RE: Letter of Credit Reduction Request #4  
Wooded Cove Estates Subdivision

**Subject: Village of Elwood – Wooded Cove Estates Subdivision**

Per your request, we have completed a review of Mr. Jeffrey Allen’s request to reduce the value of the letter of credit for Wooded Cove Subdivision (reduction request #4). Based on the summary below we recommend a new Letter of Credit of \$161,135.07.

# NORTH LIFT STATION LAYOUT PLAN 1 in = 10ft

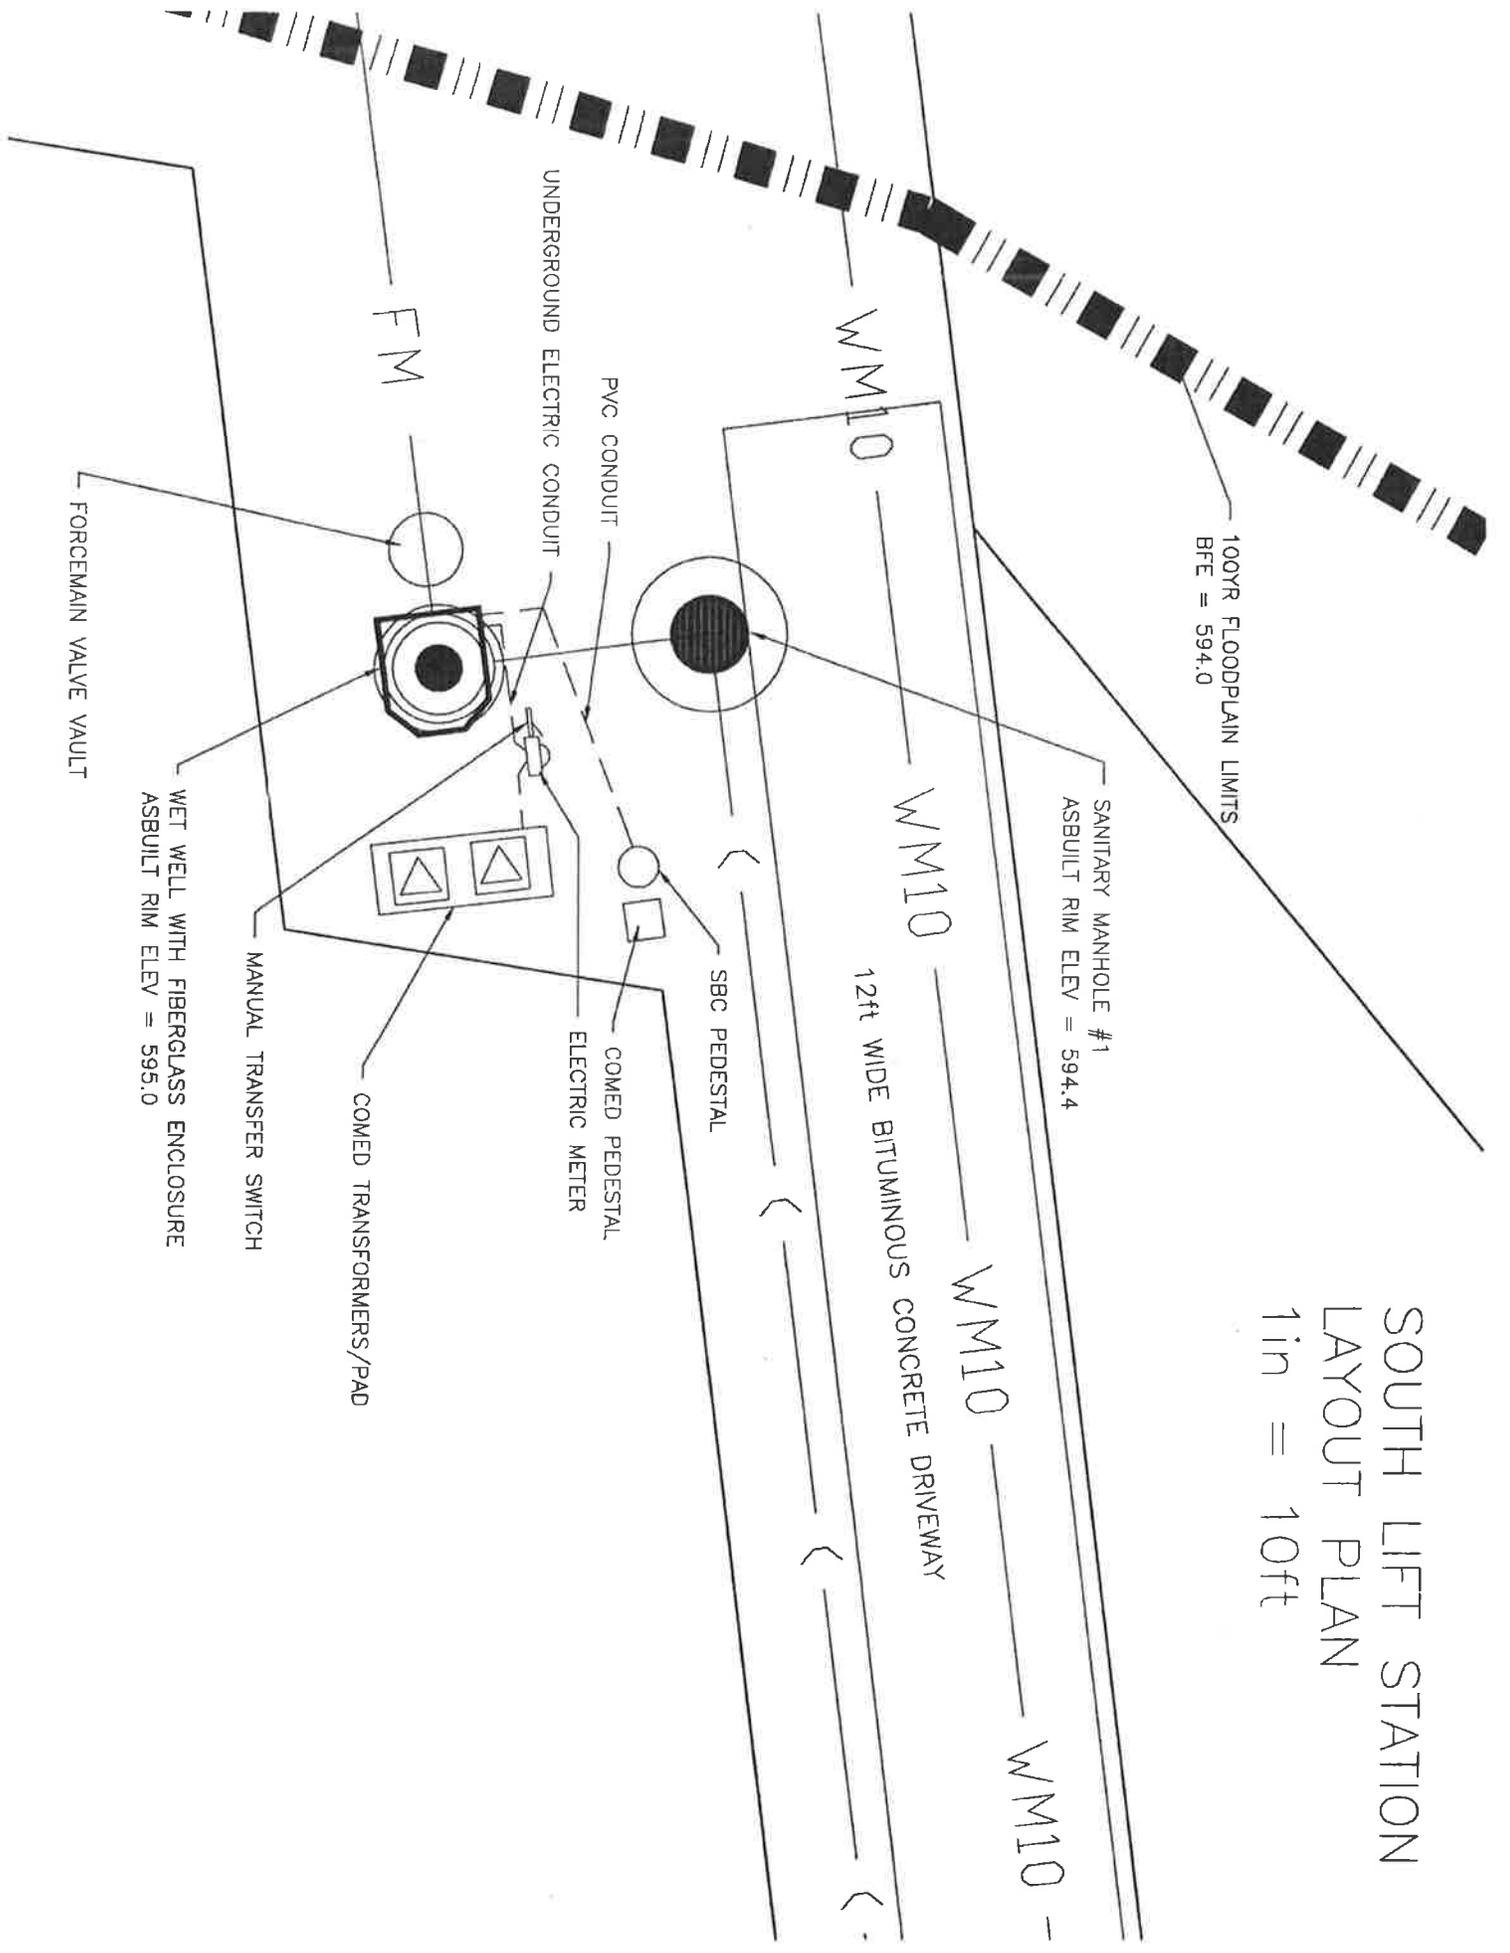
3. Site plans for both stations need to be provided showing location of all equipment including underground electrical conduits and electric utility company's transformer.

- b. The trailer towing hitch is a standard 2-5/16 hitch ball receiver.
  - c. Site plans for both stations showing the location of all equipment are enclosed.

### VERSAMATE® SERIES • PLUGS AND RECEPTACLES 100 AMP NEMA 4X METALLIC

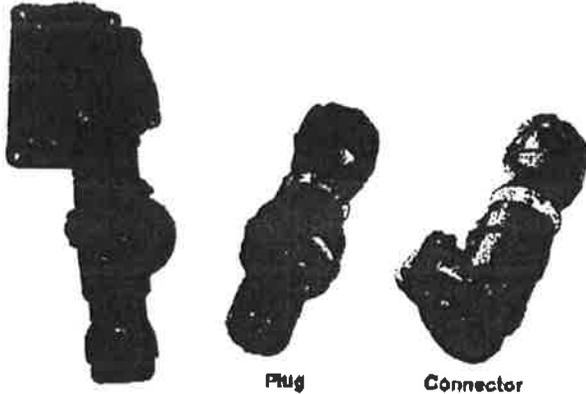
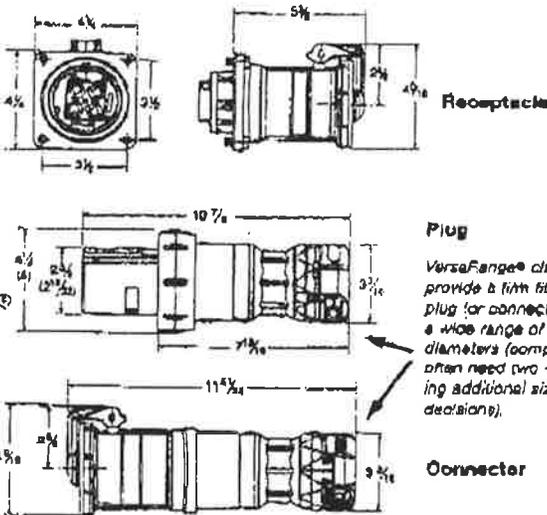
1. Provide emergency generator and address all previous comments per August 22, 2005 memo, updated October 5, 2005 (copy enclosed).
2. Provide connection for the emergency generator.
3. Repair concrete pad for control panel which has settled.

- a. The generator line circuit breaker rating is 100-amps. The A.W.G. size is #3, type THNN with 4 conductors for the output cable. A catalog cut sheet for the connector and plug is enclosed.
